Special Coverage Adjustment

N192289390 Seat Belt Anchor Pretensioner Cable

Release Date: June 2020

Subject: N192289390 - Special Coverage
Seat Belt Anchor Pretensioner Cable

4551063

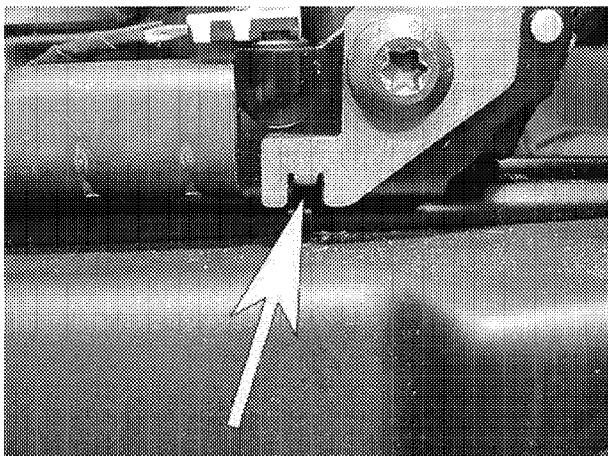
NOTE: If a tensioner bracket was installed as part of a previous service, discard the bracket. The new replacement front seat belt anchor plate tensioner design eliminates the need for the bracket.

1. Replace the driver side front seat belt anchor plate tensioner. Refer to *Front Seat Belt Anchor Plate Tensioner Replacement* in SI.
2. Replace the driver side front seat cushion outer finish cover. Refer to *Front Seat Cushion Outer Finish Cover Replacement* in SI.

4551063

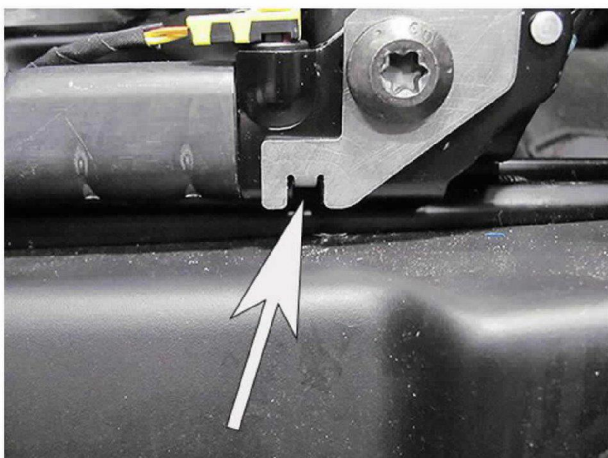
NOTE: If a tensioner bracket was installed as part of a previous service, discard the bracket. The new replacement front seat belt anchor plate tensioner design eliminates the need for the bracket.

1. Replace the driver side front seat belt anchor plate tensioner. Refer to *Front Seat Belt Anchor Plate Tensioner Replacement* in SI.
2. Replace the driver side front seat cushion outer finish cover. Refer to *Front Seat Cushion Outer Finish Cover Replacement* in SI.

4551063

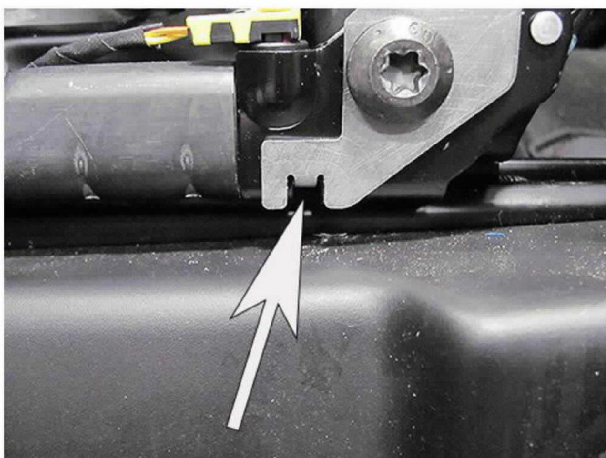
1. Replace the driver side front seat belt anchor plate tensioner. Refer to *Front Seat Belt Anchor Plate Tensioner Replacement* in SI.
2. Replace the driver side front seat cushion outer finish cover. Refer to *Front Seat Cushion Outer Finish Cover Replacement* in SI.

4551062

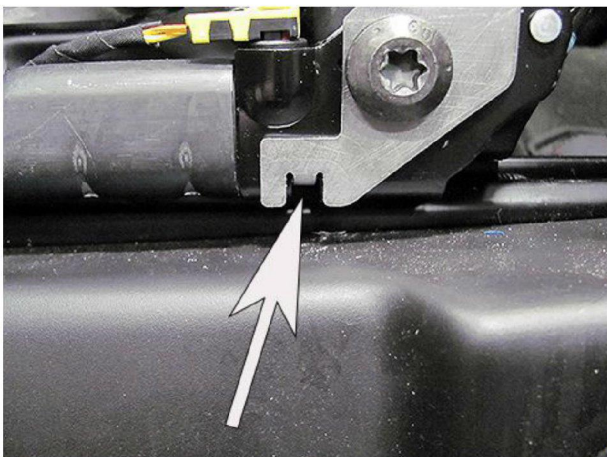
4. Ensure the tensioner cable is positioned on the outside of the tab on the bracket.

5. Assemble the tensioner assembly, service bracket and bolt.

4551063

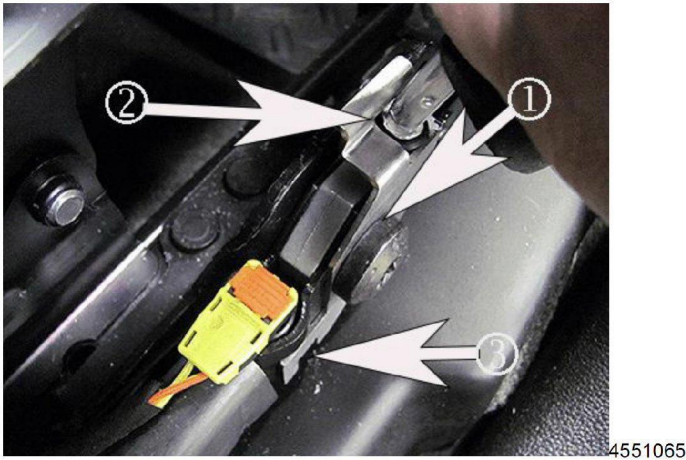
6. Start the bolt and ensure the lower tab on the bracket is correctly positioned in the notch on the tensioner.

7. Verify the bolt is seated properly (1), the cable position is correct (2) and the lower tab is correctly positioned (3).
8. Tighten the mounting bolt: **Tighten 45 Nm (33 lb ft).**
